Responses to CEC Data Requests: Nos. A1 through A123

Amended Application for Certification for HYDROGEN ENERGY CALIFORNIA (08-AFC-8A) Kern County, California

**RESPONSES TO DATA REQUESTS A1 THROUGH A123
FROM CALIFORNIA ENERGY COMMISSION (CEC)**

FIGURE A14-1

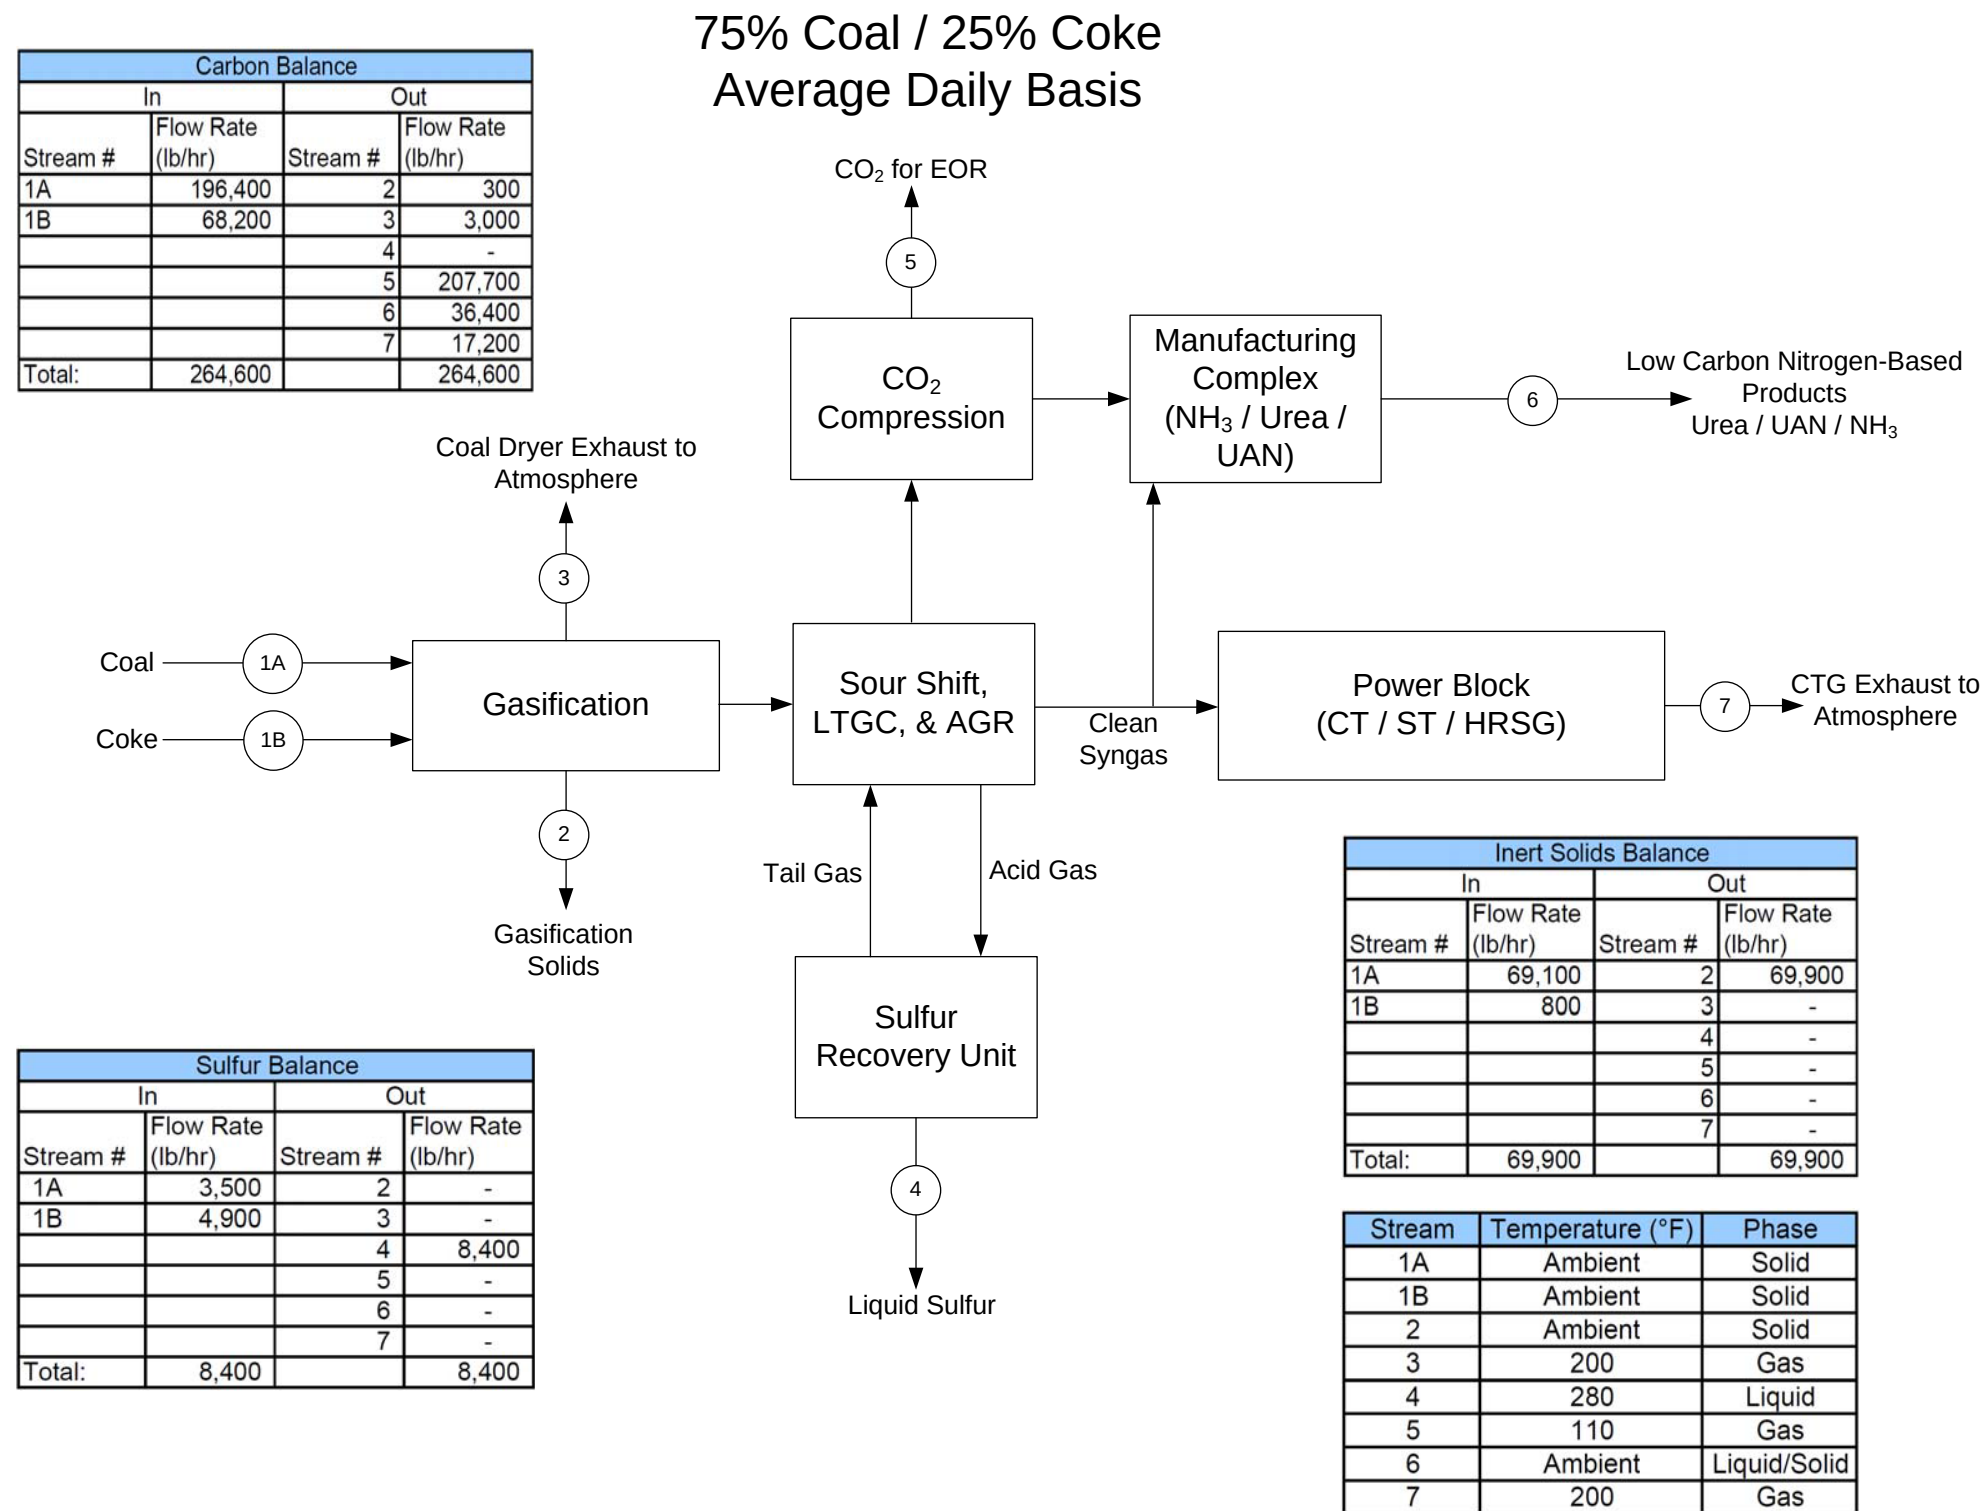
A14. Please provide energy and mass balance data for the gasification process for both petroleum coke and coal, including the new coal dryer. The mass balance data should clearly show carbon (and carbon compounds), water, sulfur, volatile organic compounds (VOC), toxic air contaminants (TACs), and total solids contents throughout the process. The energy balance should identify each stream's phase (gas/liquid/solid) and include the temperature at the various steps through the processes.

Figure A14-1, Mass Balance of Carbon, Sulfur, and Inert Solids, and Figure A14-2, Mass Balance of Water, present the overall material balances, temperatures, and stream phase (i.e., solid, liquid, or gas) for carbon, sulfur, inert solids, and water in the plant feeds, products, by-products, emissions, and wastes for the entire Project.

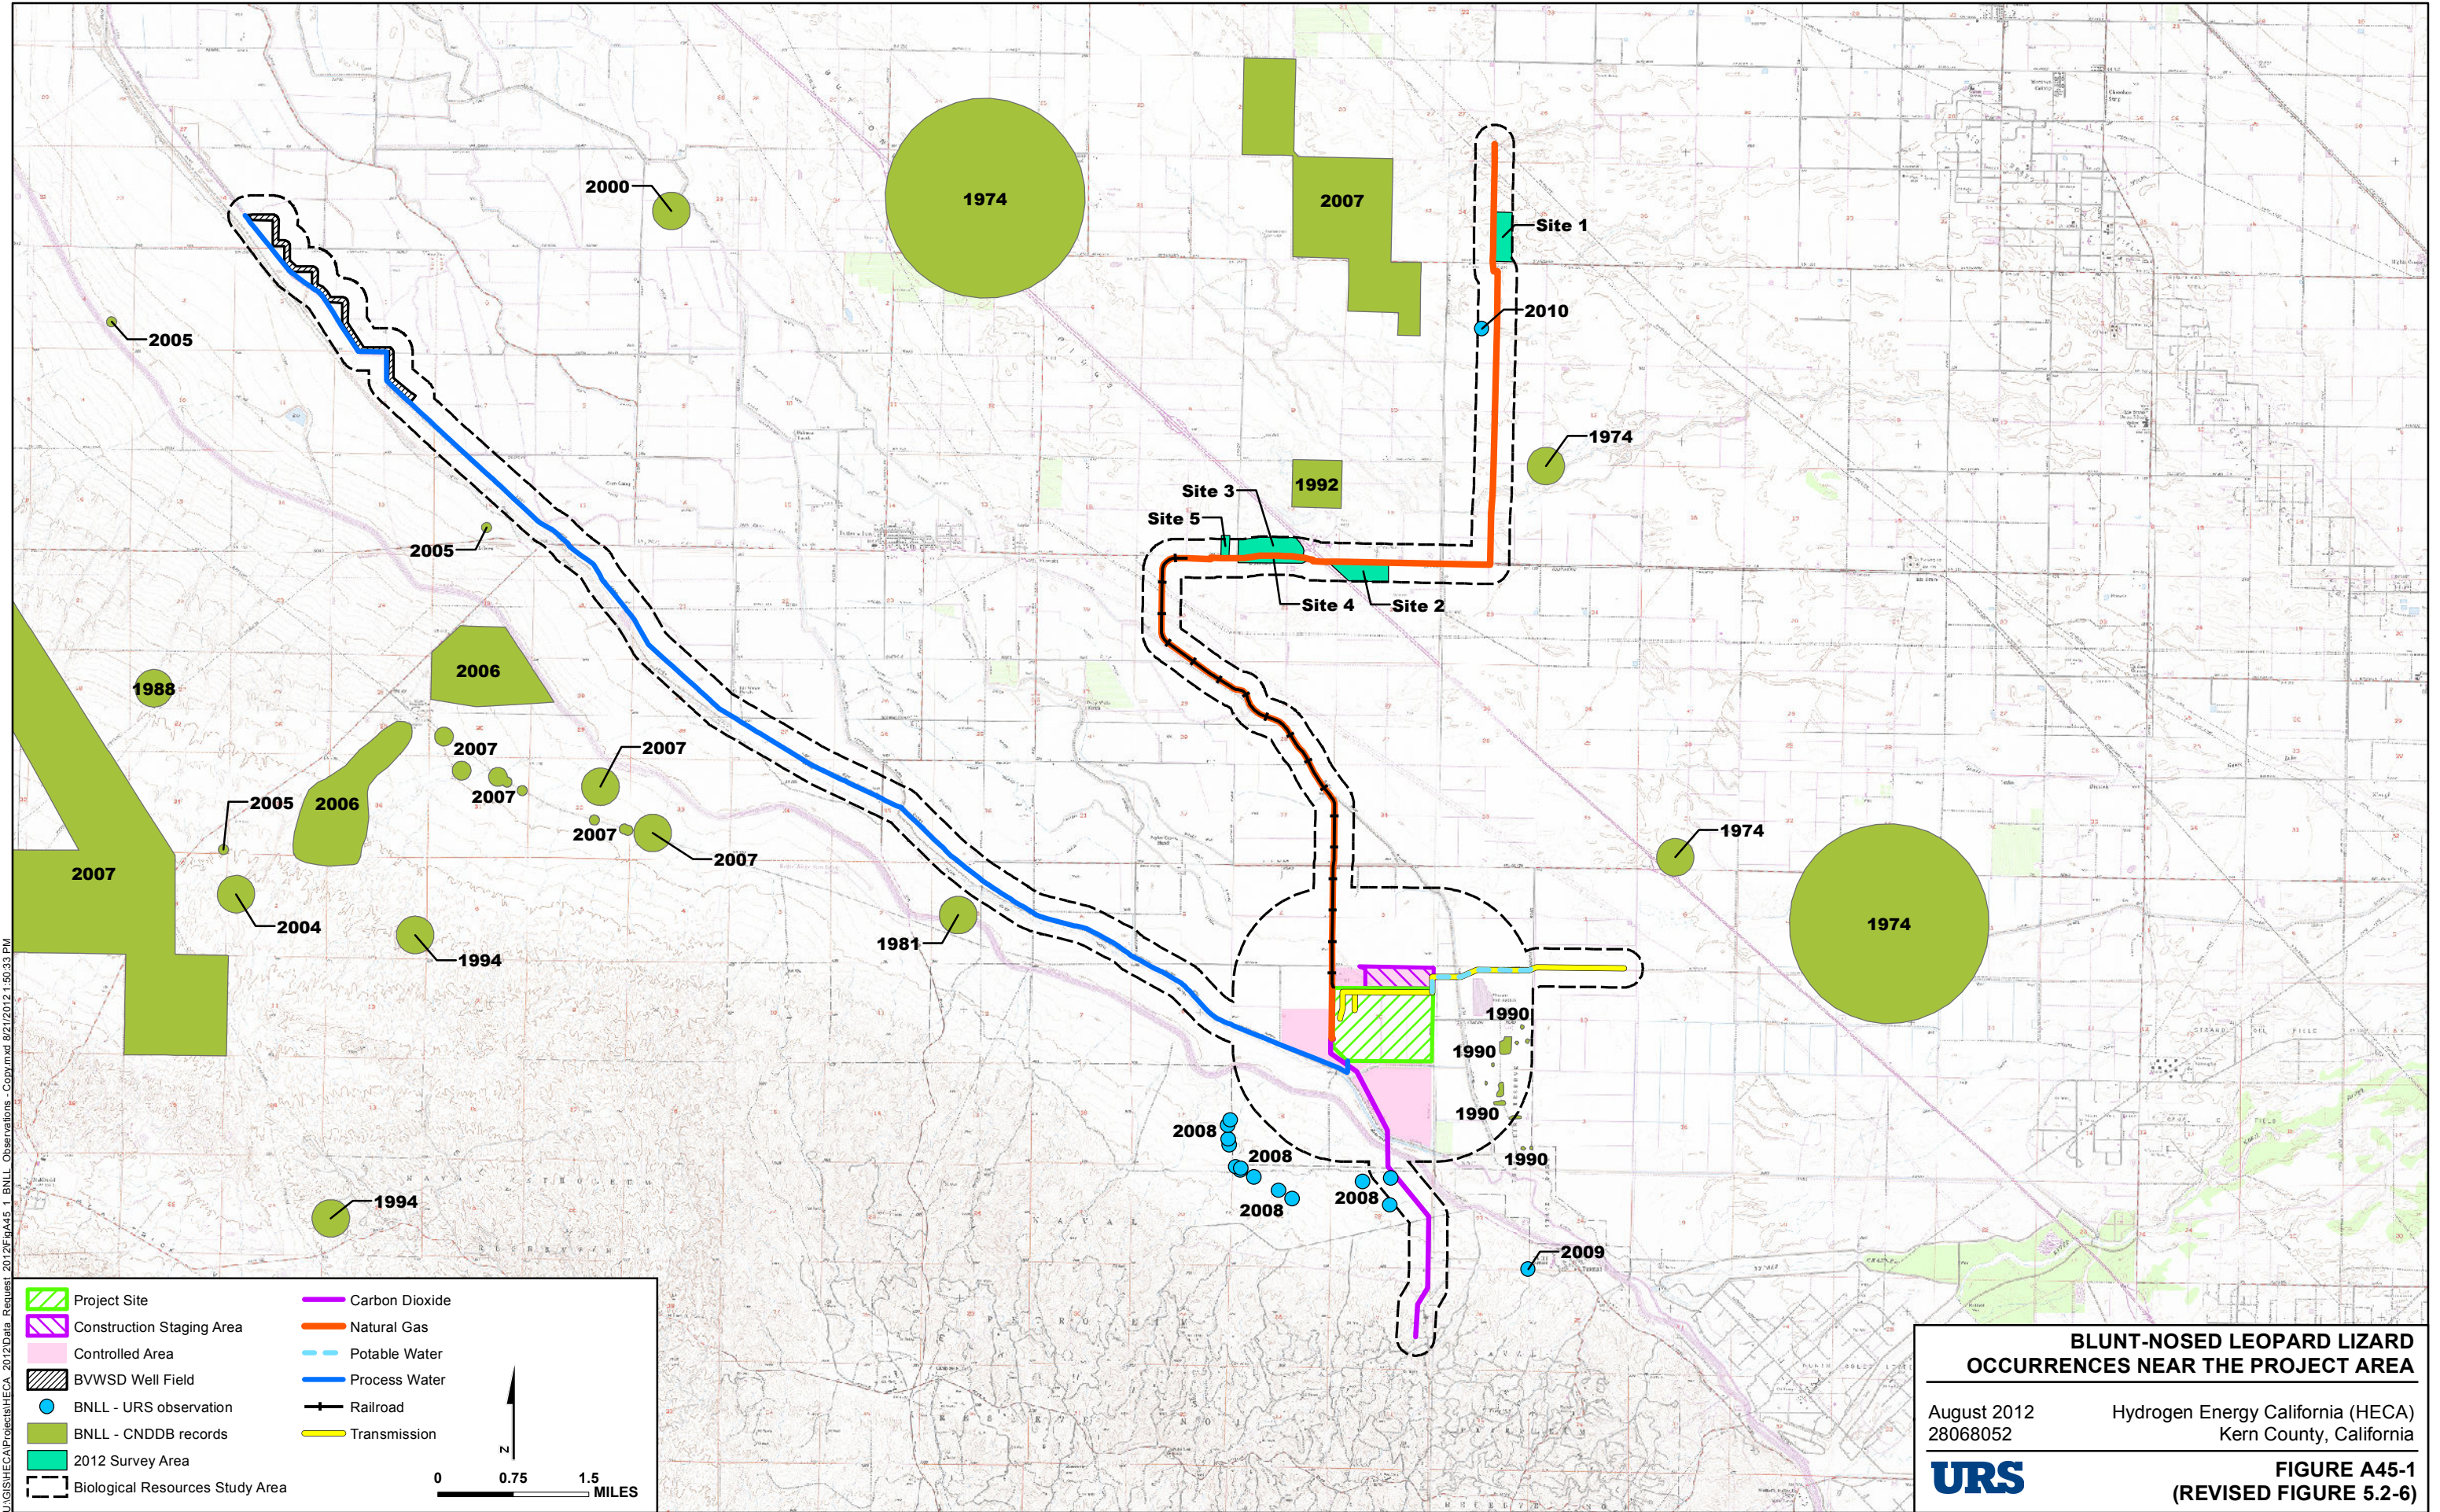
A45. Similar to Figure 5.2-6 in the Amended AFC, please provide three separate graphics showing all collected “URS-observation” GPS data, to date, for: 1) special-status plant species 2) burrowing owl and sign and 3) San Joaquin kit fox and sign. Also, please update Figure 5.2-6 with current blunt-nosed leopard lizard survey findings.

No blunt-nosed leopard lizards were detected during the 2012 adult surveys conducted on the five sites identified on Figure A45-1 (Revised Figure 5.2-6). Table A44-3 details the results of surveys conducted in 2012.
